Britt T. McKinney
Sr. Vice President & Chief Nuclear Officer

**SUSQUEHANNA STEAM ELECTRIC STATION
PROPOSED LICENSE AMENDMENT
NUMBERS 285 FOR UNIT 1 OPERATING LICENSE NO. NPF-14
AND 253 FOR UNIT 2 OPERATING LICENSE NO. NPF-22
CONSTANT PRESSURE POWER UPRATE
PLA-6002**

**Docket Nos. 50-387
and 50-388**

FIGURE 3.1.7-1

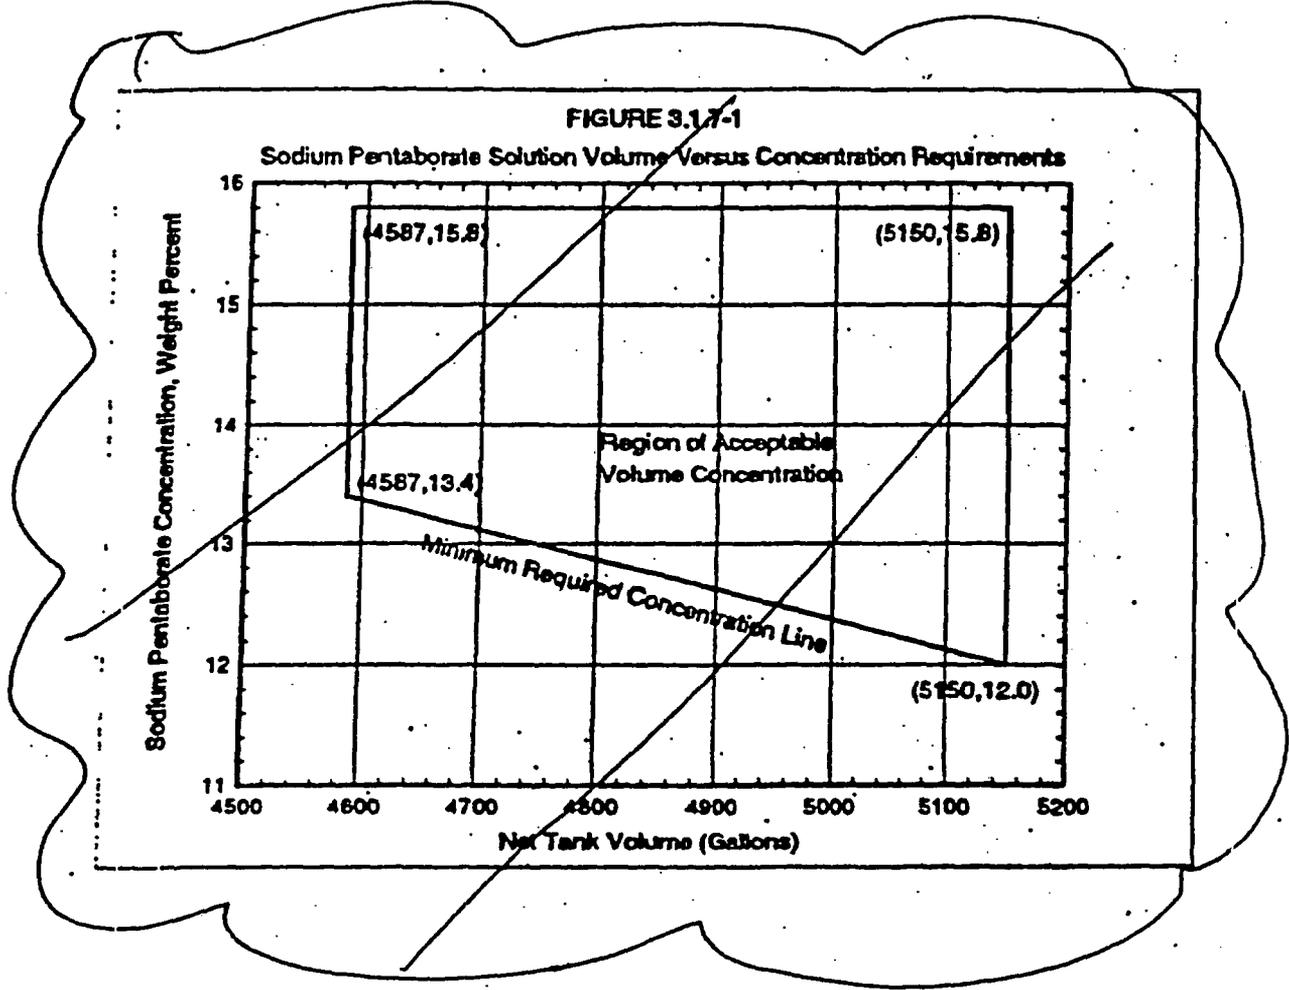
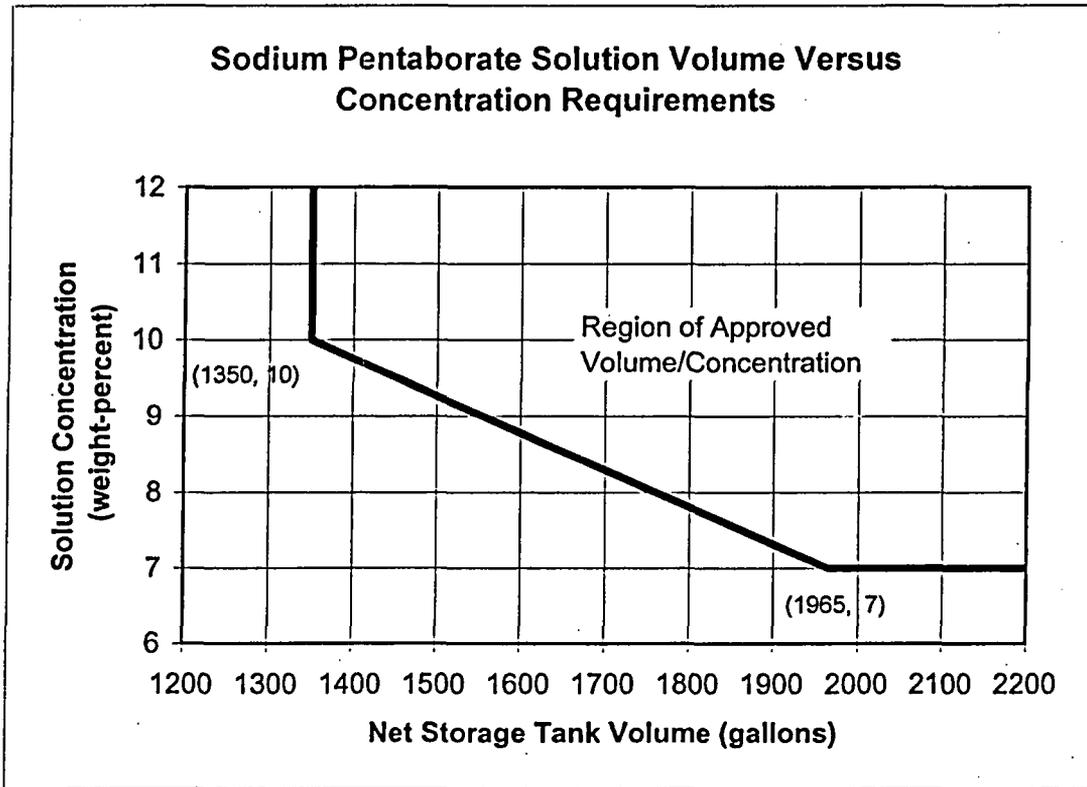
- 9) Replacement of Figure 3.1.7-1 to reflect the lower required sodium pentaborate concentration versus tank volume, which reflects the use of enriched boron; and

3.1.7, SLC System, Figure 3.1.7-1	Revises the curve providing sodium pentaborate volume versus concentration requirements to provide for the use of enriched sodium pentaborate.	See CPPU PUSAR 6.5 and 9.3.
